MEMORANDUM

Our Ref: EP/DC/PP/2018/0887

Location: O. S Grid Ref: 348 543 Bryn y Groes, Chester Road, Gresford, Wrexham.

Development: Amended site layout and substitution of house types on plot nos. 22 – 33.

Turning Areas

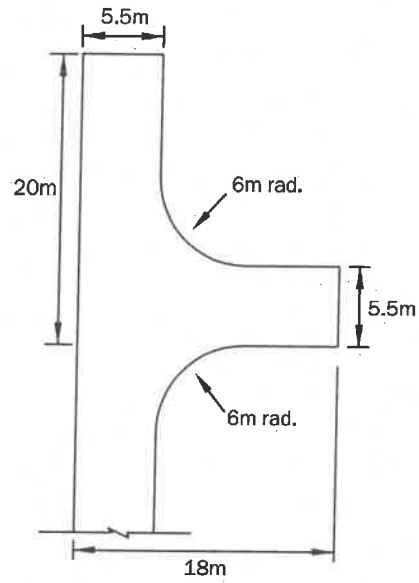
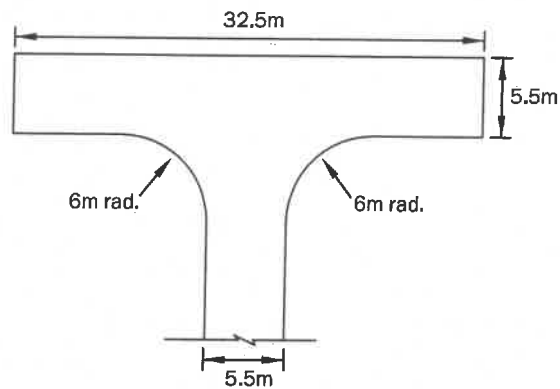
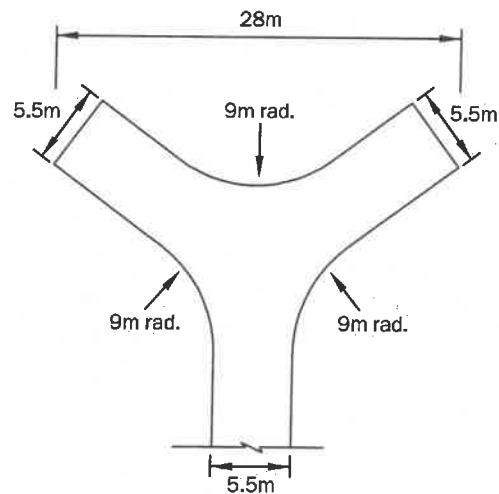
- The turning head indicated on the submitted layout plan is of insufficient size to accommodate the turning movements of an 11.2m long refuse vehicle. Could you please ask the applicant to provide a revised plan indicating a turning head to adoptable standards (see attached detail).

Turning areas are based on an 11.18m long, 2.55m wide refuse vehicle.
